Garofalo & Associates, Inc.

RE: *Coventry Crossings Mixed Use Development*
(Plat 10, Lot 29 & Plat 18, Lot 86)
Nooseneck Hill Road (Route 3), Coventry, Rhode Island
GAI PN: 7398.00

On behalf of the Applicant, KREG New Homes, LLC, *Garofalo & Associates, Inc.* (*Garofalo*) is hereby submitting the following discussion and/or materials in response to TRC/staff comment received.

RE: COVENTRY CROSSINGS
Preliminary Submission – Agency Review Status
AP 10 Lot 29 & AP 18 Lot 86
Harkney Hill Road
Coventry, Rhode Island

Vehicle Tracking Vehicle Details

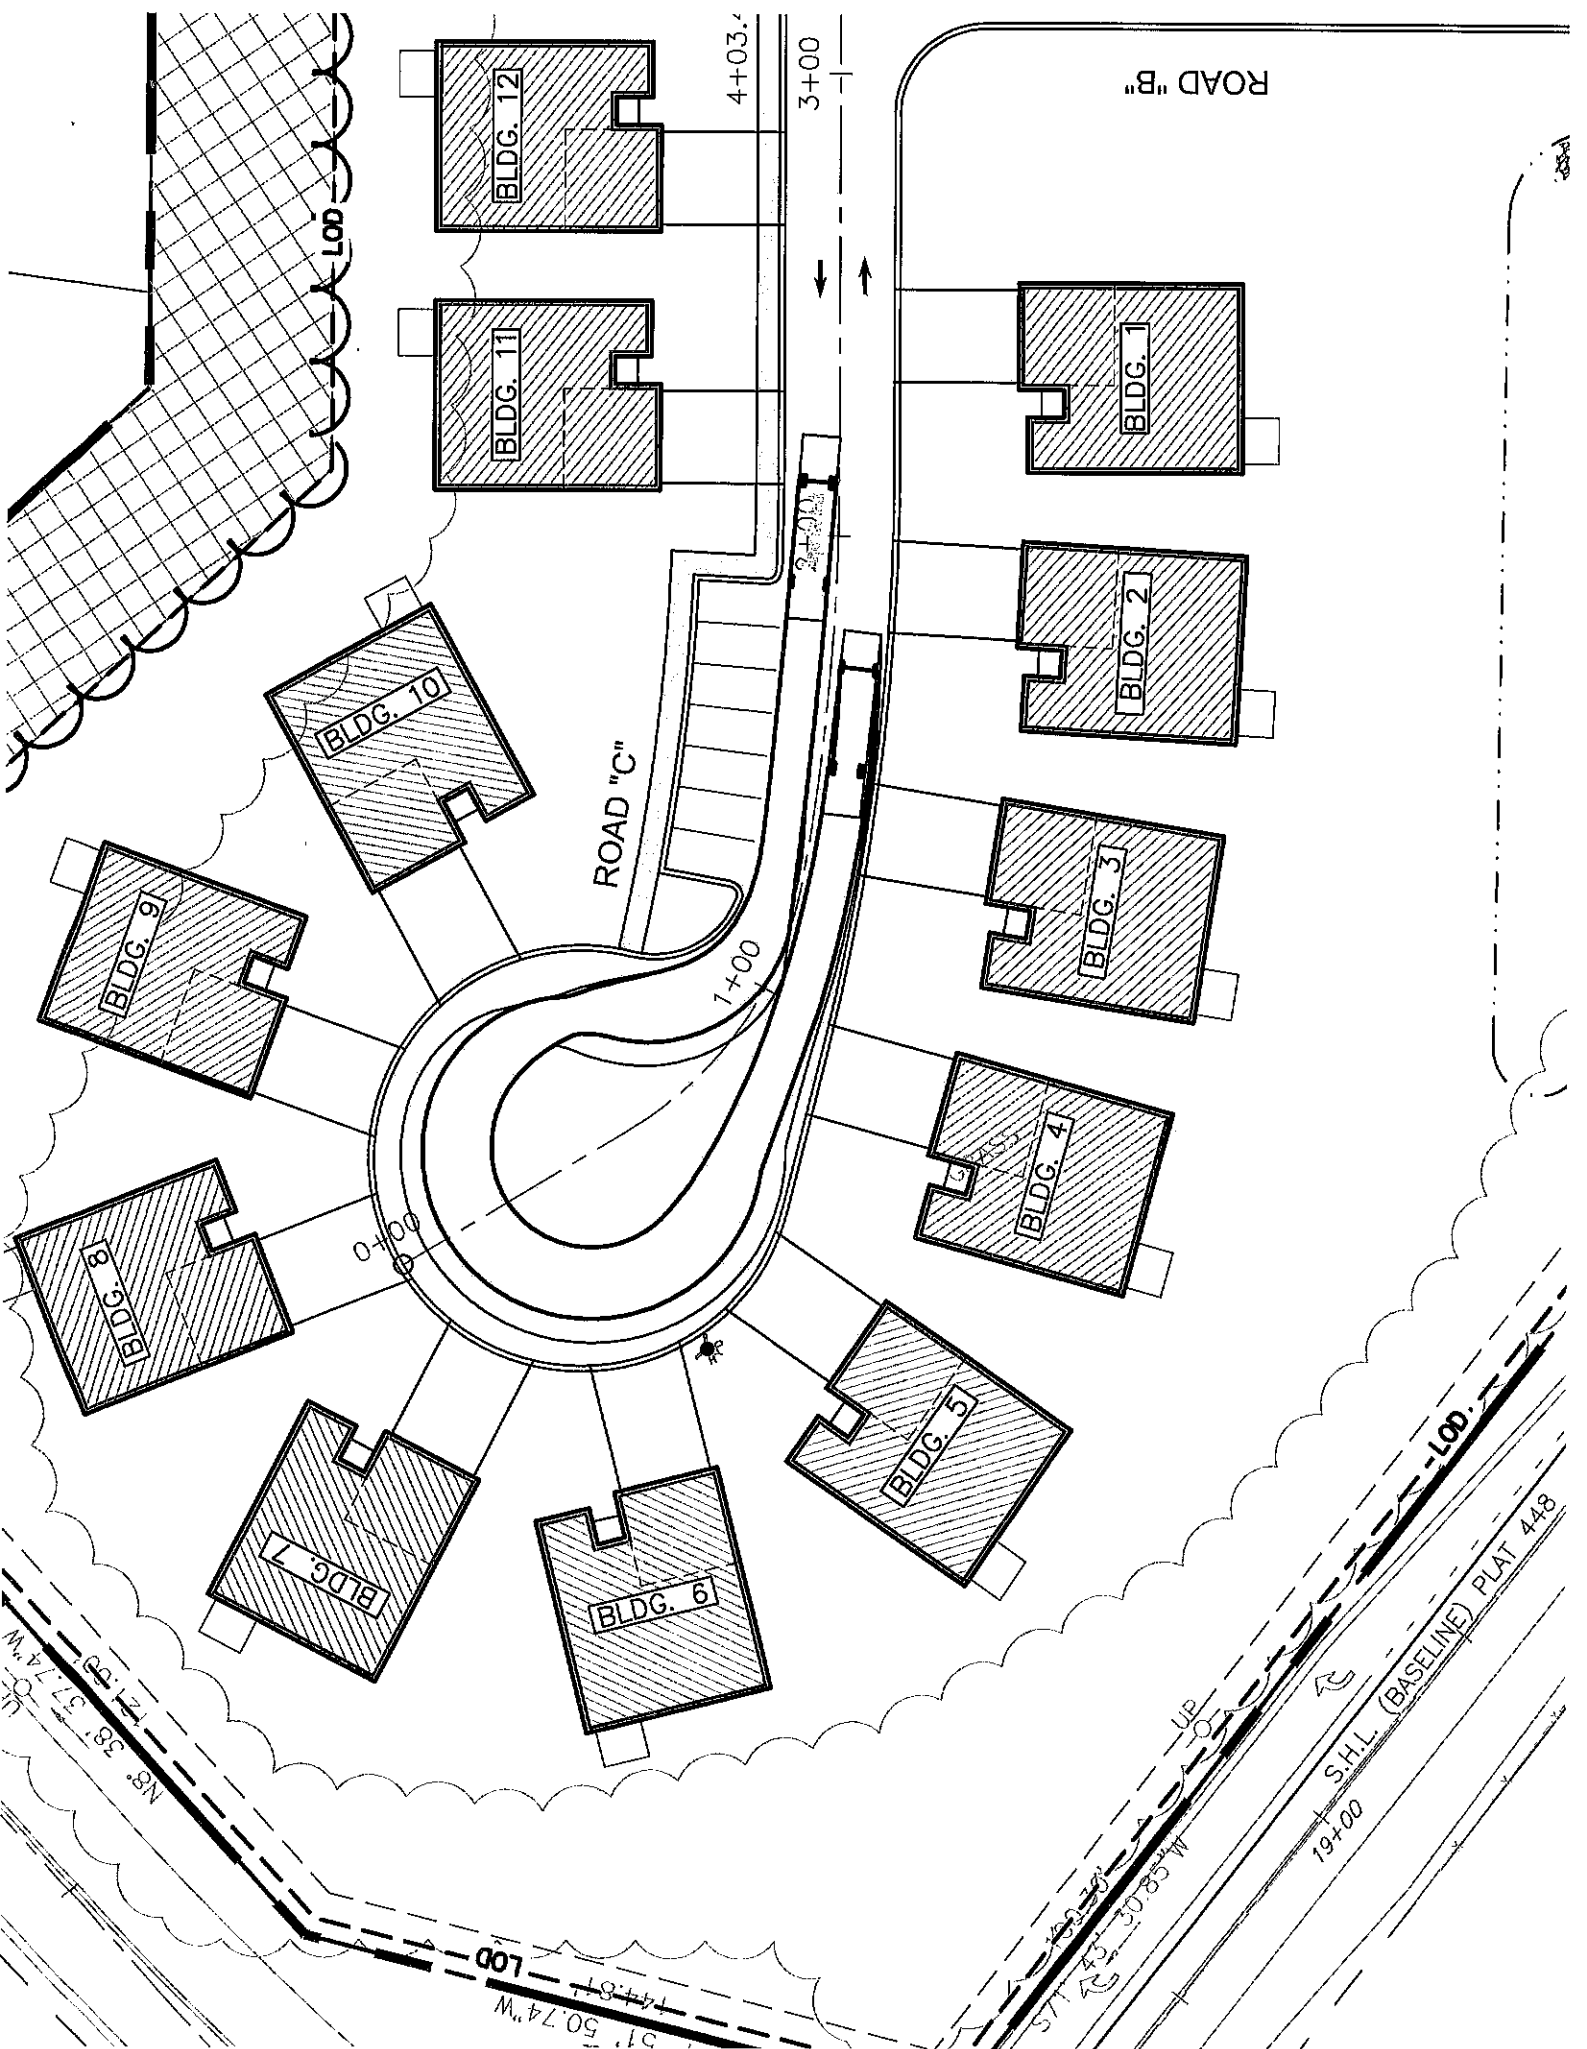
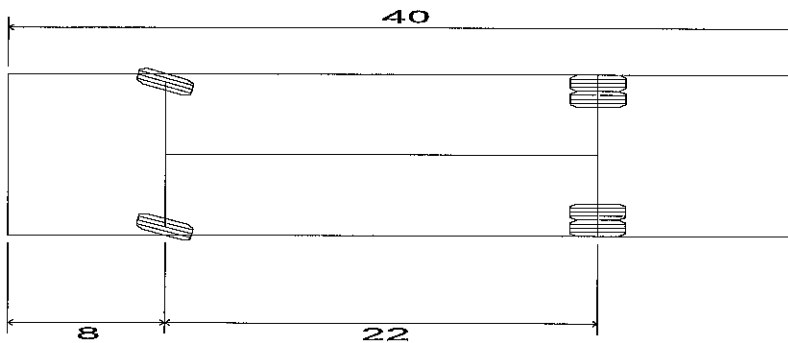
3. If there are cul-de-sac must be of size to turn around fire apparatus.

An emergency vehicle turn-around template is attached.
